Subject: Response to Comments on FDER's Technical Evaluation

Agrico Chemical Company

Permit Files AC53-201152, AC53-199112, PSD-FL-179

CEM DATA SUMMARY SULFUR DIOXIDE EMISSIONS - NO. 10 SULFURIC ACID PLANT

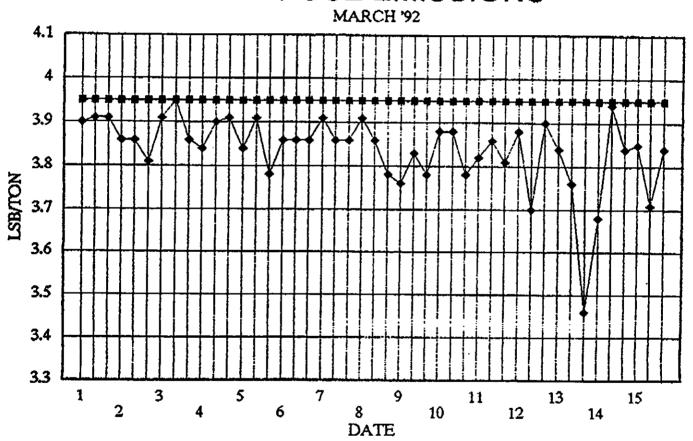
Attached is a typical emission scenario based on actual CEM data for sulfuric acid plant No. 10 during March, 1992.

FDER and EPA concur with the applicant's BACT review for the double absorption sulfuric acid plants. A sulfur dioxide emission limit of 4.0 lb/ton of 100 percent acid is appropriate for the Nos. 10 and 11 sulfuric acid plants despite a compliance test result of 3.21 lb/ton for the following reasons:

The emission rates vary with time and cannot be guaranteed at 3.21 lb/ton because:

- The emission rates vary with variations over time in the process temperature, pressure, SO2 concentrations, conversion efficiency, absorption efficiency, etc.
- The catalyst efficiency varies from the time it is replaced until it is next replaced during a plant turnaround.

It would be impractical to impose an emission limit so close to a level corresponding to normal operations that any variation would result in excess emissions. This could bring about a situation where while operating under normal conditions, a plant would be in compliance with an emission limit 50 percent of the time and out of compliance 50 percent of the time.
